DEVELOPMENT SERVICES COUNCIL REPORT

File No: DP 21-01

Subject: **Application No. DP 21-01 – Development Permit with Variances (2405 Bering Road)**

Figure 1 – Site plan showing landscaping and designated pedestrian accesses to the site.

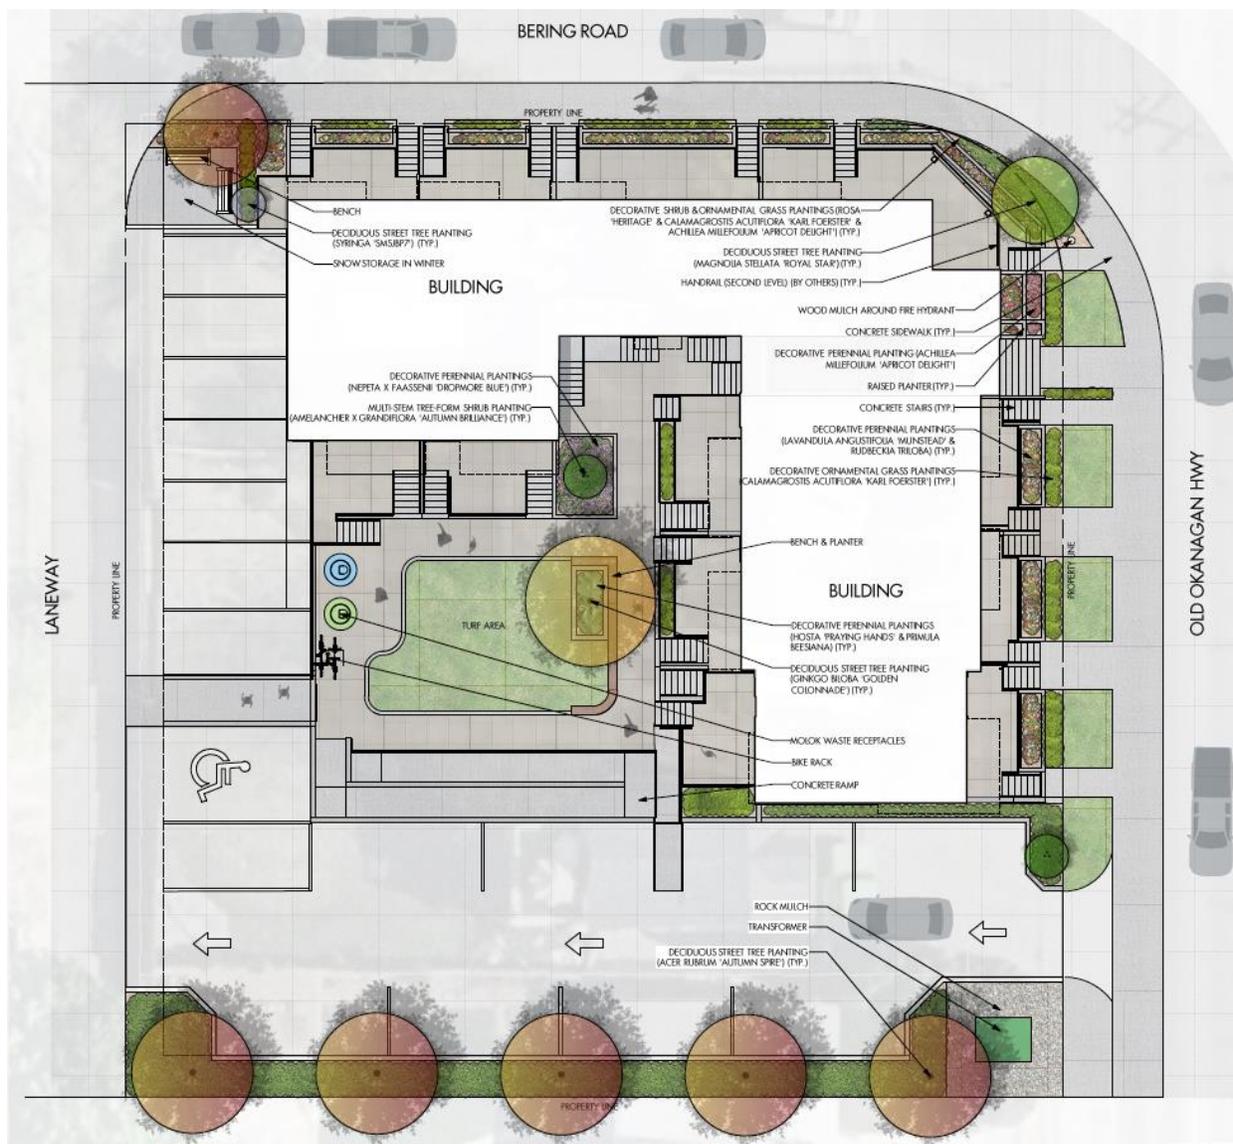
- Landscaping is provided on private property to respect and improve the streetscape and public realm (Guideline s.4.2.12.1.)
- Development clearly delineates and provide separation between vehicular routes and pedestrian routes to minimize all potential conflicts and make pedestrian routes easy to distinguish. (Guideline 4.2.11.2)

Figure 4 – reduced parking setback for one parking space along the exterior side parcel boundary from 3.0m to 1.5m.

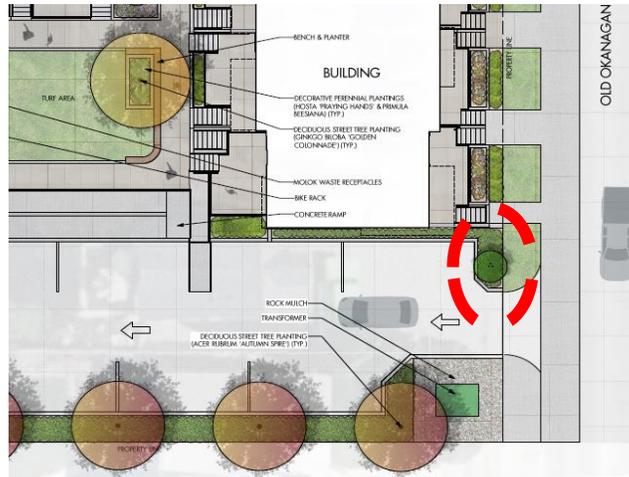
The minimum 3 meter setback requirement for parking is to limit the visibility of parking areas from the street and provide space for landscaping. Only one parking stall is within 3 meters of the exterior side parcel boundary. Instead, a 1.5m setback has been provided for this stall which is the requirement for interior side and rear parcel boundaries. Landscaping is provided between the parking space and the street (Figure 4).

This variance is supported as it effects one parking space and allows the development to maintain a parking ratio of one space per unit. Landscaping is provided to screen the parking space.

Figure 5 – 14 parking spaces provided for the 14 townhouse units, 1 accessible parking space, and 2 visitor parking spaces.

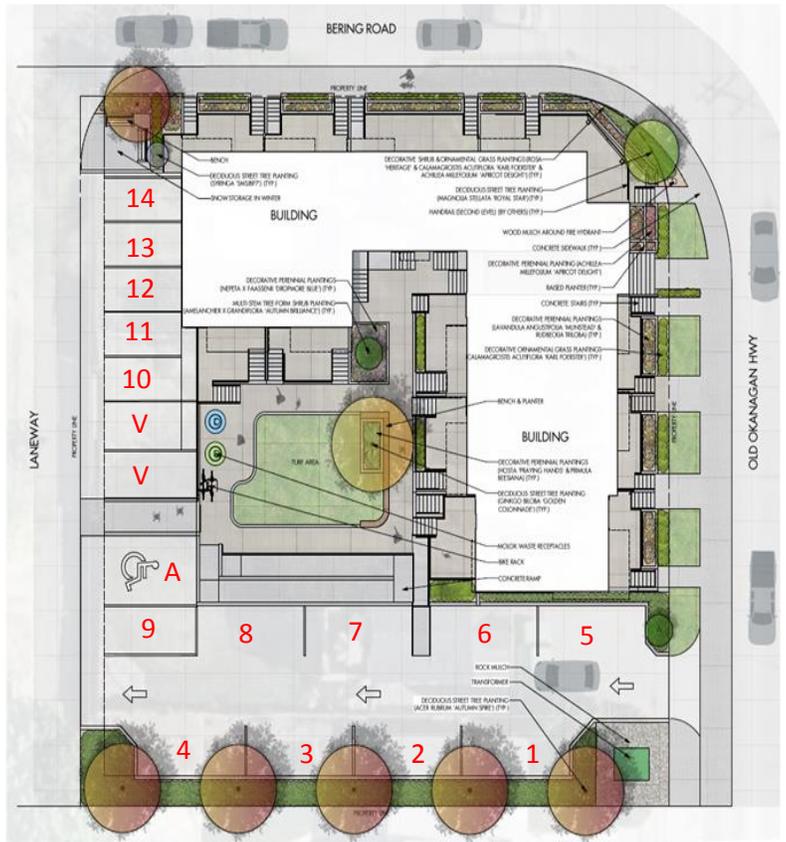
The reduction in 2 standard parking spaces is due to the limited area on the site available for parking. The development instead proposes a parking ratio of 1 parking space per unit (Figure 5).

This variance is supported as a parking ratio of one space per unit is maintained for the development proposal. In addition, the development continues to offer the 2

Figure 6 – increased driveway width and reduced drive aisle width to facilitate parking adjacent to the rear lane.

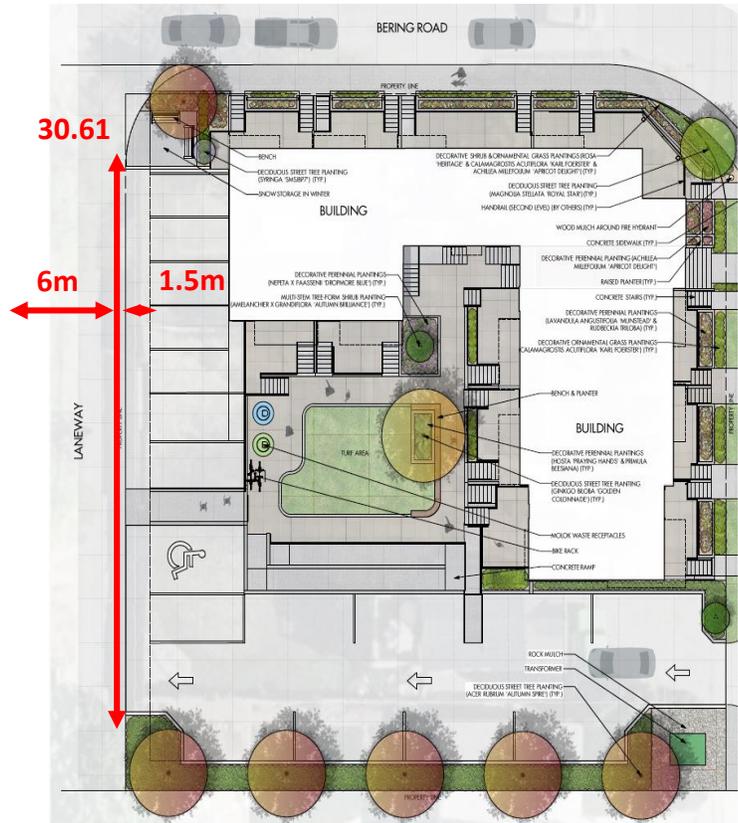
The increased driveway width and decreased drive aisle width are to accommodate parking accessed from the laneway. The increased driveway width is due to the parking spaces being accessed directly from the lane. The reduced drive aisle width is due to the required 7 meter drive aisle calculated using the laneway (6 meter laneway + 1.5m aisle on property = 7.5m drive aisle) (Figure 6).

These variances are supported as they allow the majority of parking to be accessed from the rear laneway leaving the front of the property for pedestrian connections to the site. The laneway and additional width on the parcel together provide sufficient space for the maneuvering of vehicles in and out of the site.
